September 14, 2012  
NRC:12:049

**AREVA NP Inc. Evaluation of Sleicher-Rouse Heat Transfer Correlation**

## Attachment A

Figure 1. Calvert Cliffs PCT Trace and SIT Discharge Flow with Corrected Sleicher-Rouse correlation – 3.83-in Break

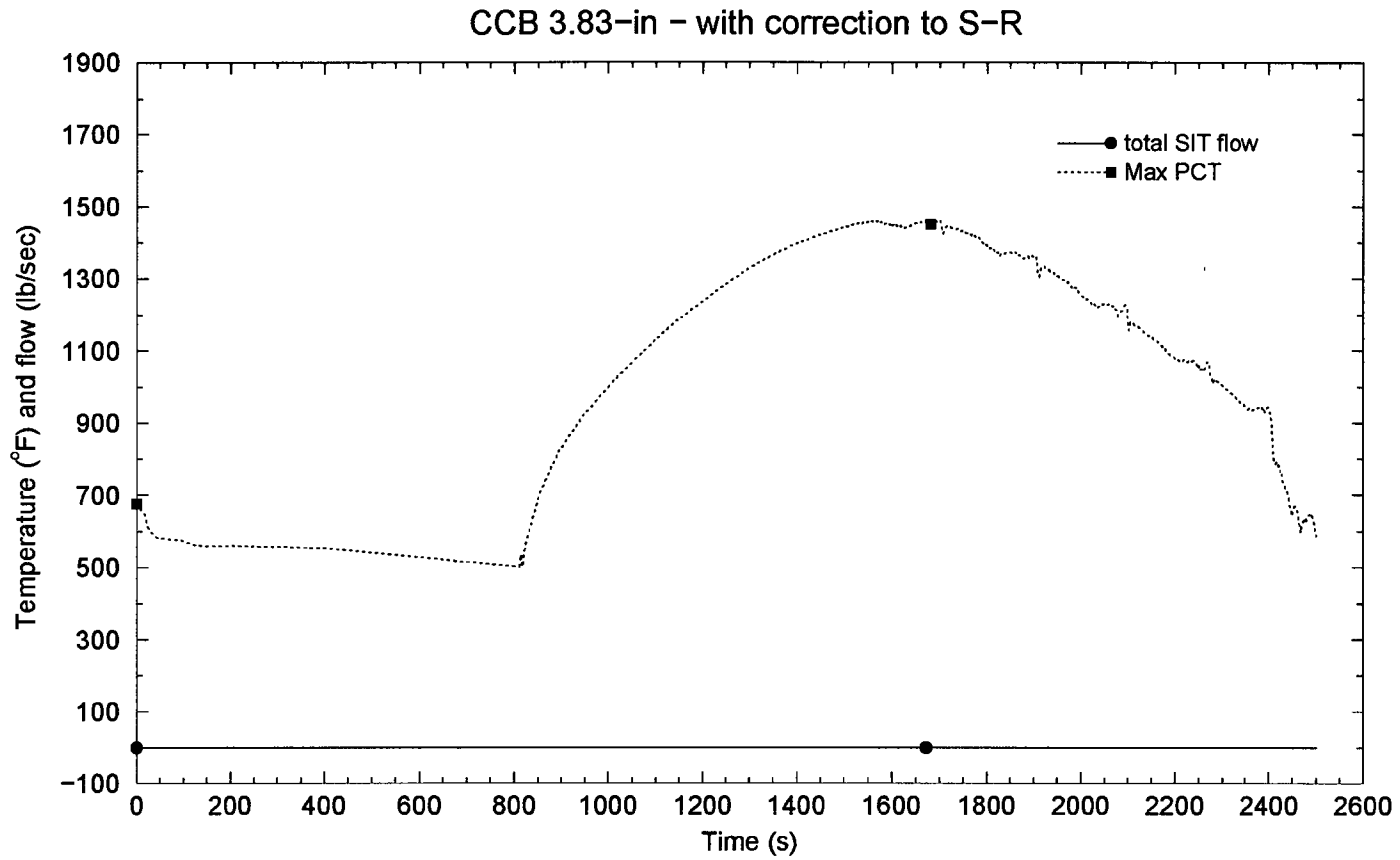
### ***NRC Action 2: Confirm that CE 2700 MW class plants found the case that delays the Safety Injection Tanks injection the longest.***

For Calvert Cliffs the SIT never discharges for break sizes smaller than the limiting one. In the case of Palisades, the SIT beginning time is very close to that of PCT time for most of the break sizes run, including the limiting case. For an equivalent diameter of 0.060 inches for Palisades, the SIT never injects.

Figures 1 through 10 show the maximum PCT trace, and accumulator discharge for the limiting break, and for the prior break, for all plants except SONGS and the Fort Calhoun EPU. For SONGS the smallest and largest

Table 2 shows the safety injection tanks (SIT) injection time for all the analyzed CE cases with the corrected Sleicher-Rouse correlation. In all plants, the break size has been adequately refined (within 0.25 in diameter) to show the maximum peak clad temperature (PCT) and SIT discharge behavior with increasing break size. Except for SONGS and Fort Calhoun extended power uprate (EPU) SBLOCA analyses, all other CE plants analyses in Table 2 show the largest break size that results in the PCT occurring before the cold leg SIT discharge (or no discharge at all), and the smallest break size that results in the PCT occurring after the cold leg SIT discharge. This can be shown by comparing the maximum PCT and beginning SIT timings in Table 2 for the limiting break size and all the breaks prior:

In conclusion, the smallest break size (diameter) case that cause the longest delays of the SIT injection are identified as follows:

Figure 11. SONGS PCT Trace and SIT Discharge Flow with Corrected Sleicher-Rouse correlation - 8.97-in Break

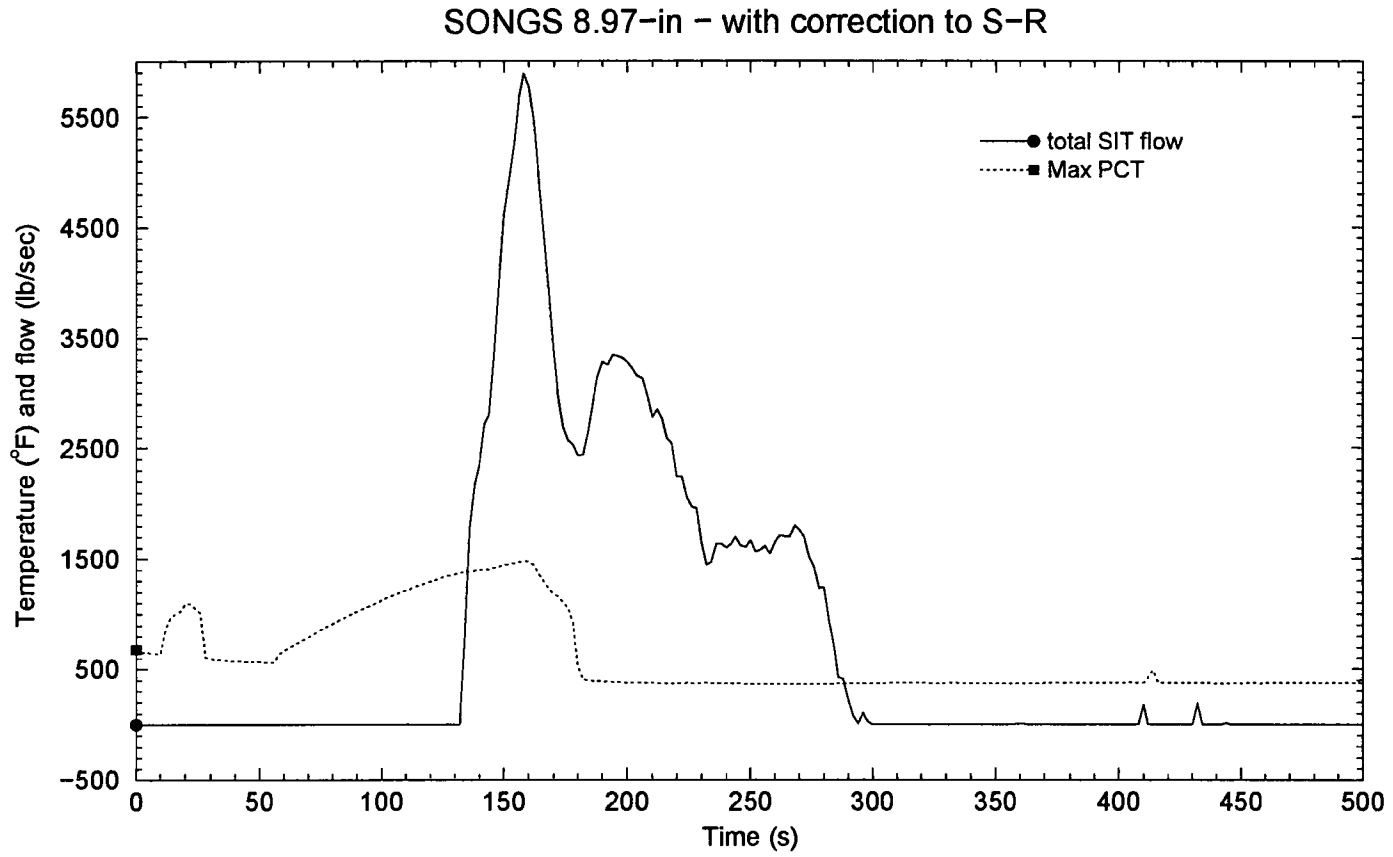
For San Onofre Nuclear Generating Station (SONGS), the SIT start time becomes greater than the PCT time for break sizes smaller than 8.50-in in the original analysis, which were not run in the corrected Sleicher-Rouse correlation analysis. Again, only the cases surrounding the limiting case within the 0.25-inch diameter were examined.

break sizes analyzed are shown in Figures 11 and 12. Based on this explanation for Fort Calhoun EPU, plots were not necessary.
